February 14, 2011

Subject: CPV Sentinel Energy Project
Docket No. 07-AFC-3C
Construction Laydown Area Refinement

URS **FIGURE 7.3-5**

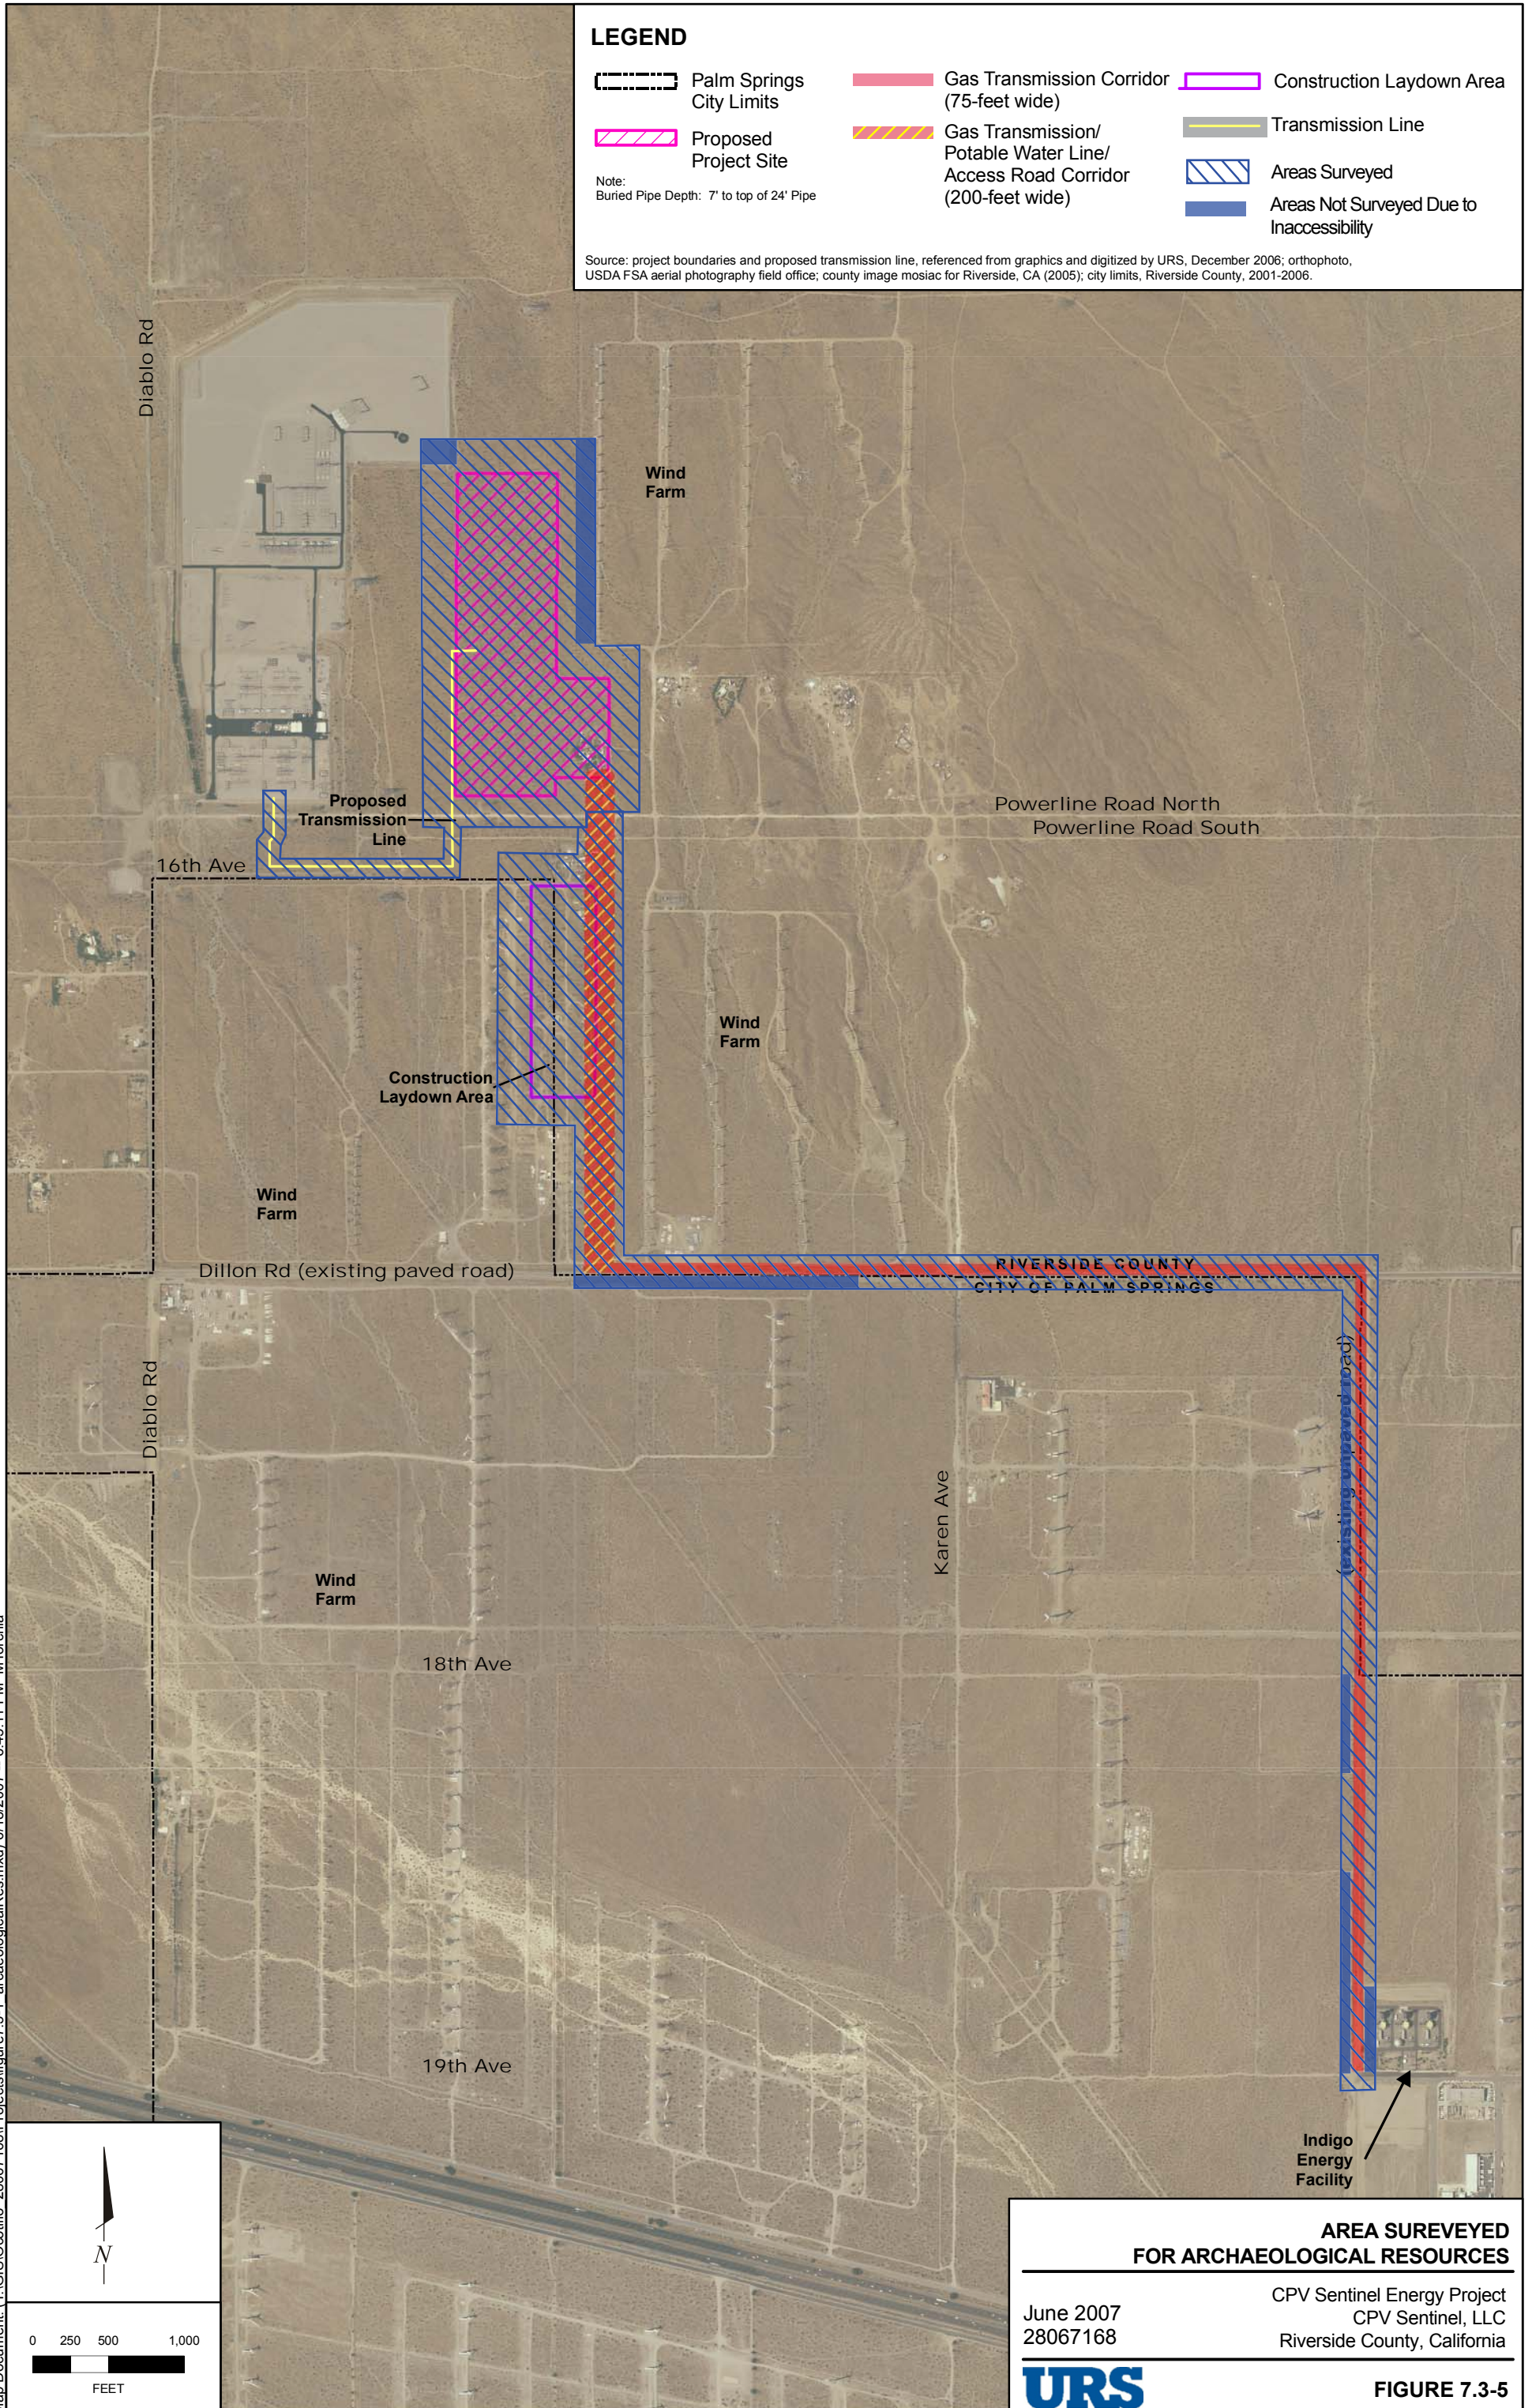
The 50-foot-wide area now affected by construction laydown was previously surveyed for cultural resources, as shown on AFC Figure 7.3-5 (attached for reference). No cultural resources were identified in the 50-foot segment now affected by the construction laydown area (see Section 2.2.7 and Figure 6 of the Confidential Cultural Resources Technical Report).
